project: SPPS Facilities Master Plan (Creative Arts Pathway)

school: Linwood Monroe Lower

Variance Request - Attachment C

Submittal Date: January 9, 2017
Project: Linwood Monroe Arts Plus Elementary School Addition and Remodel
Subject: Response to Neighbors Concerns

ATTACHMENT "D"

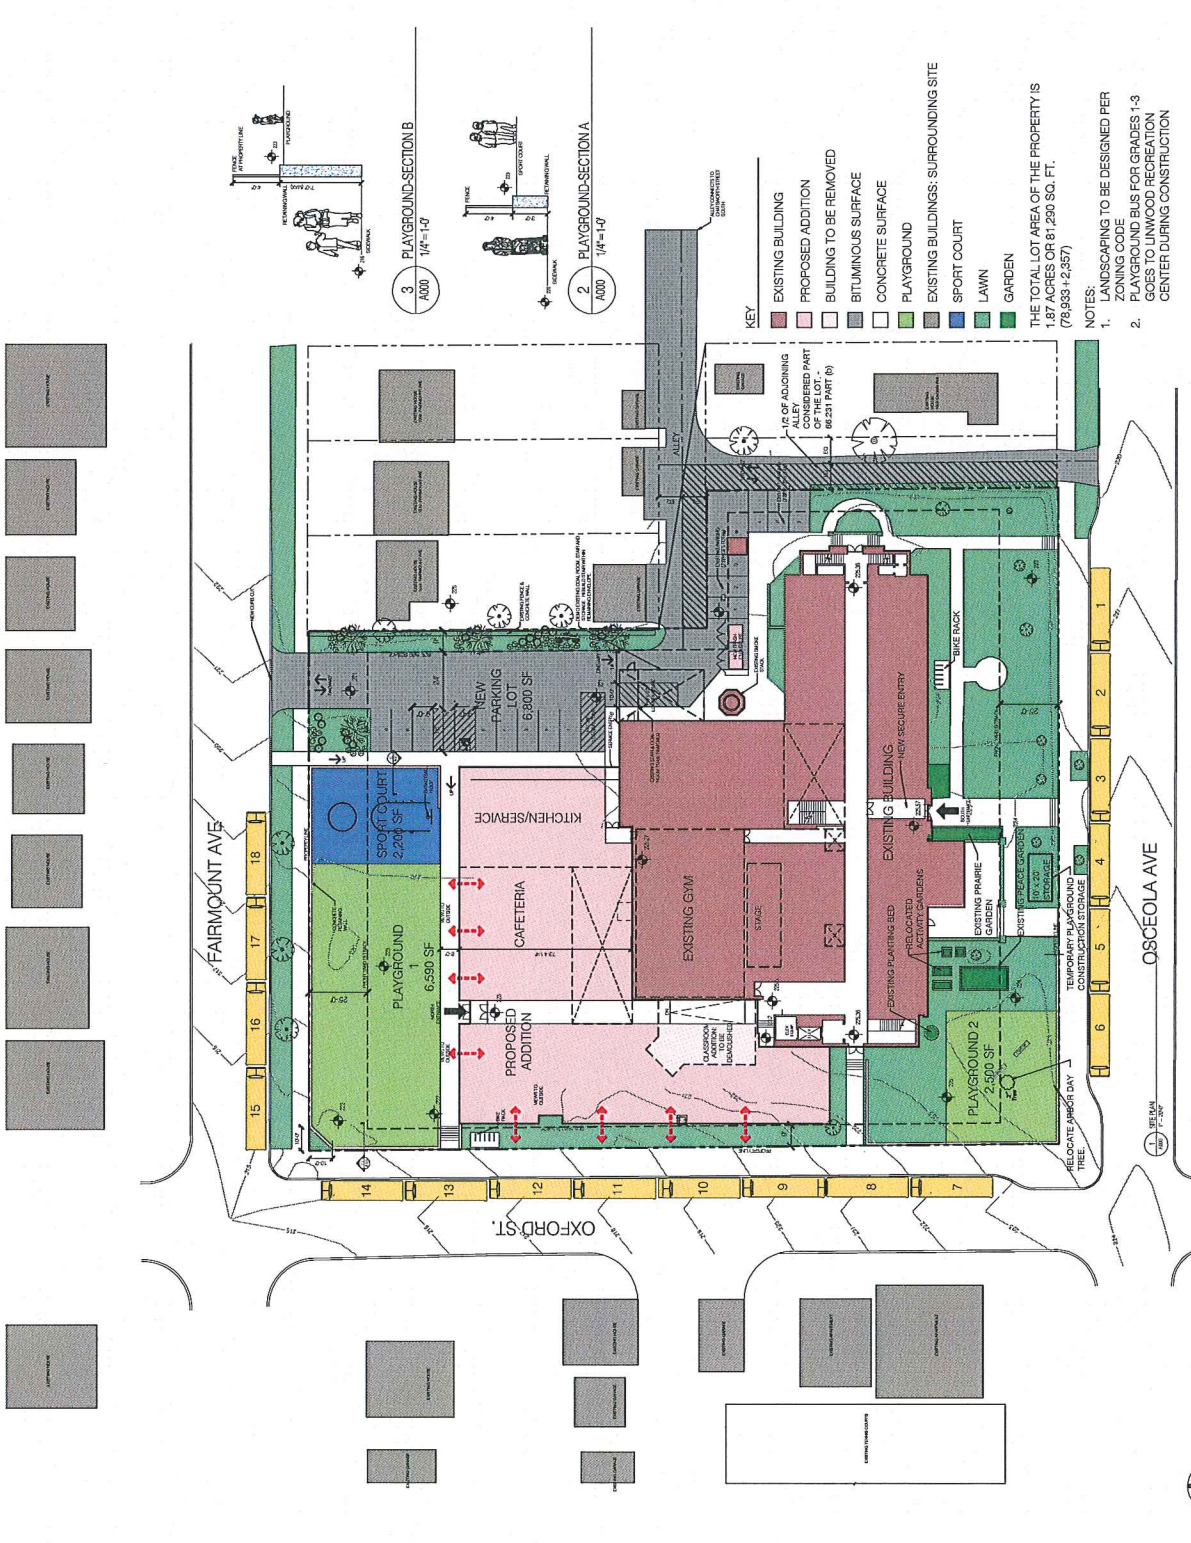
- 1) The preservation of as much open space as possible.
- 2) The removal of the driveway/alley, parking lot, and curb cut on the Fairmount side. We believe most neighbors would prefer a variance for on-street parking.

- 3) Limiting the building's lot coverage to what is allowed under city code. We suggest this can be accomplished by building up within the existing footprint of the building, over what appears to be the gym and historic coal shed.

- a. Design Response
 - i. Removed the curb cut and driveway to Fairmont entirely.
 - ii. Removed existing boiler and coal rooms.
 - iii. More play areas for the children of the neighborhood and the school.

- iv. Safer access and maneuvering of service vehicles.
 - v. Required parking counts achieved without a variance for parking in front yard.
 - vi. ADA parking access to north door.

- a. Design Response
 - i. Reduced our original lot coverage request from **44.3%** to **38.5%** by removing the antiquated boiler and coal rooms and shifting the parking and building mass; however, we cannot accommodate the schools educational needs within the 35% lot coverage of the R4 district.

ATTACHMENT "E"

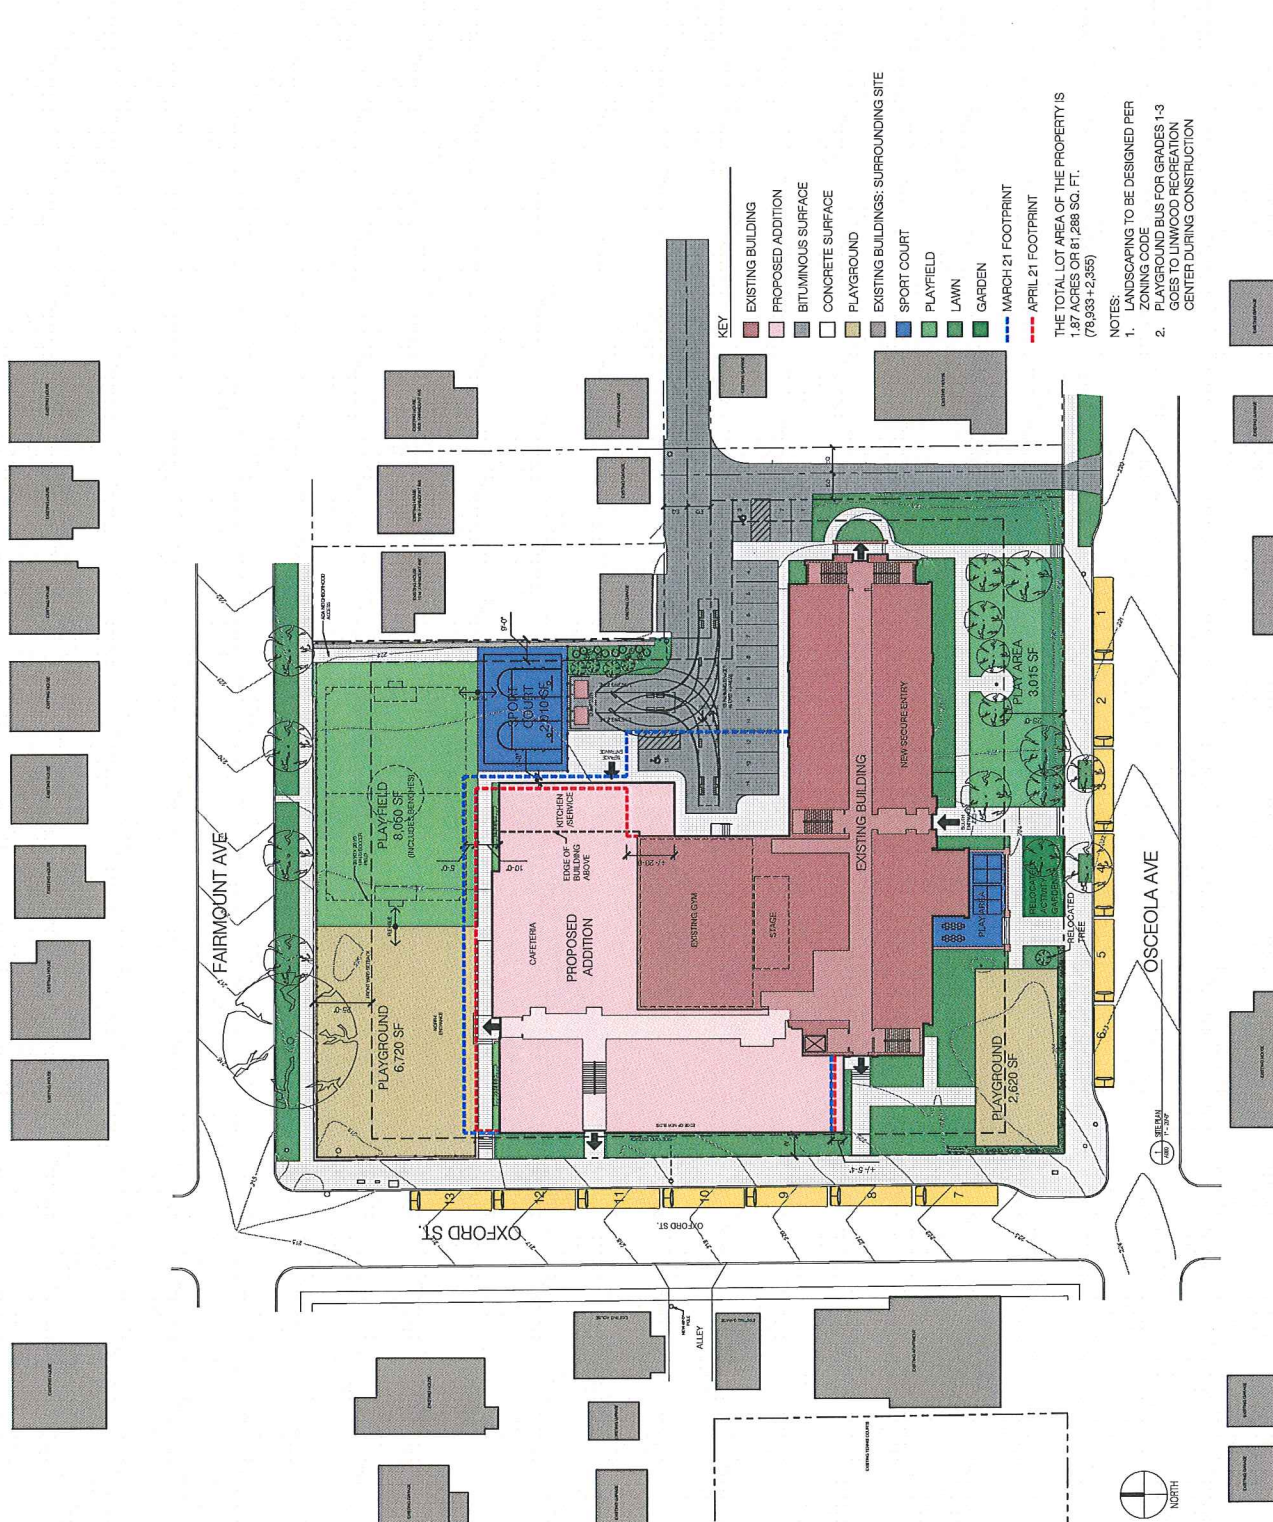
- 1) "The preservation of as much open space as possible."
 - a. Design Response
 - i. Lot Coverage
 1. Reduced our original lot coverage request from **44.3%** to **38.5%** by removing the antiquated boiler and coal rooms and shifting the parking and building mass.
 - ii. Expanded North Total Play Area (Playground, Sport Court and Playfield)
 1. Moved the north edge of the addition 15'-0" and moved the side walk 2'-0" for a total of 17'-0" additional.
 2. Pulled back the east edge of building 2'-8"
 - a. We attempted to pull this east edge back even further, but a more in-depth code review required another exit stair at this corner of the building.
 - iii. Total Play Area Comparison
 1. Existing Play Area
 - a. 25,980 SF
 2. Withdrawn Variance Play Area (March 21, 2016)
 - a. 11,383 SF
 3. Revised Play Area (January 9, 2017)

- a. 23,217 SF
 - b. Net decrease of 10.6% from existing.
 4. The outdoor space available on the north side now extends roughly 80 feet from the sidewalk to the addition – plenty of room to implement a new, safe, and accessible playground as well as a U8 soccer field and hard-surface play area with basketball hoops.

- 1. See the Variance Site Plan **Attachment E**.
 - ii. The revised parking interior to the Linwood site will be screened with landscaping adjacent to the nearest neighbor and screened by a backstop at the sport-court areas.

SECTIONAL SHADOW COMPARISON

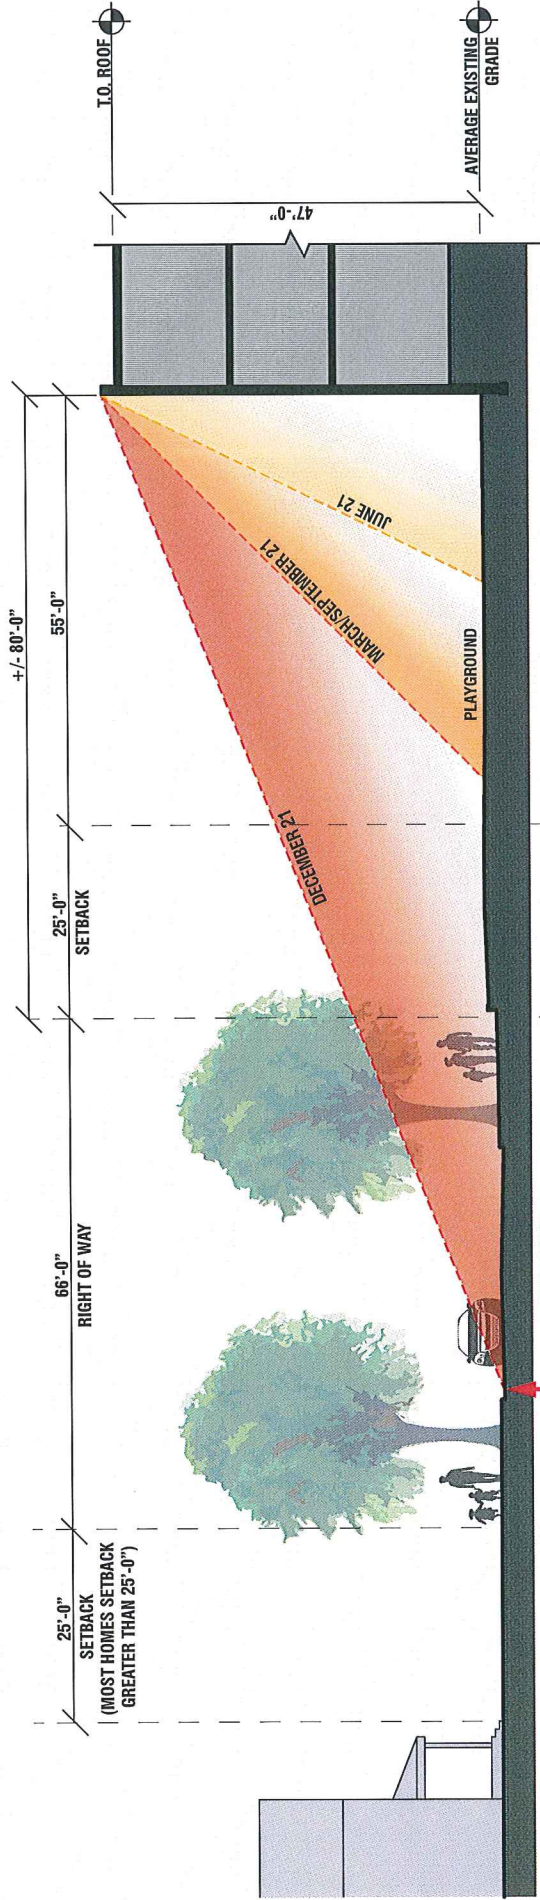
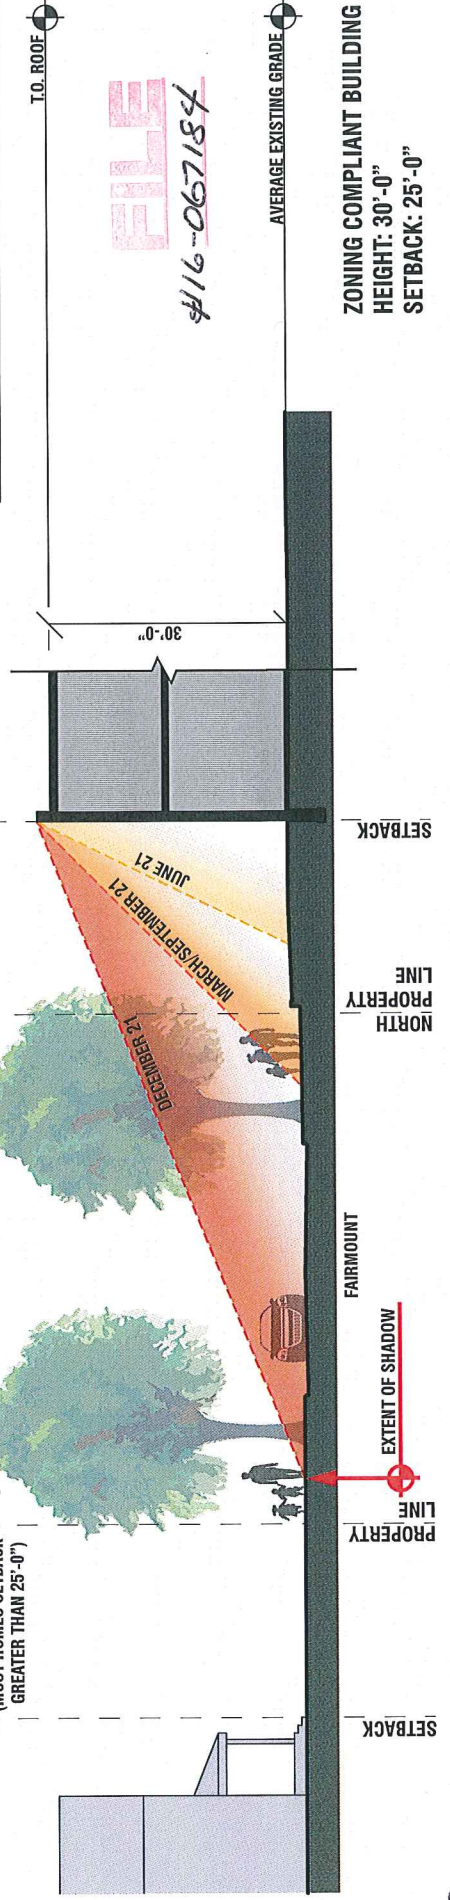
- 4) To not host ECFE classes on the site - nor to build that capacity into the building.
- 5) To limit the height of the building as much as possible, ideally within the code requirements. (Note - we did not discuss this, but I meant to.)

1. Based on a detailed survey of the property, we reduced our height variance request from 50' to 47'
 2. The parapet height of the Addition will match the existing parapet height of the original 1922 building.

- ii. Penthouses
 1. Mechanical penthouses are set back from the primary facades to reduce their appearance and per the zoning code do not count in building height calculations.

PROPOSED SCHOOL ADDITION
HEIGHT: 47'-0"
SETBACK: +/- 80'-0"
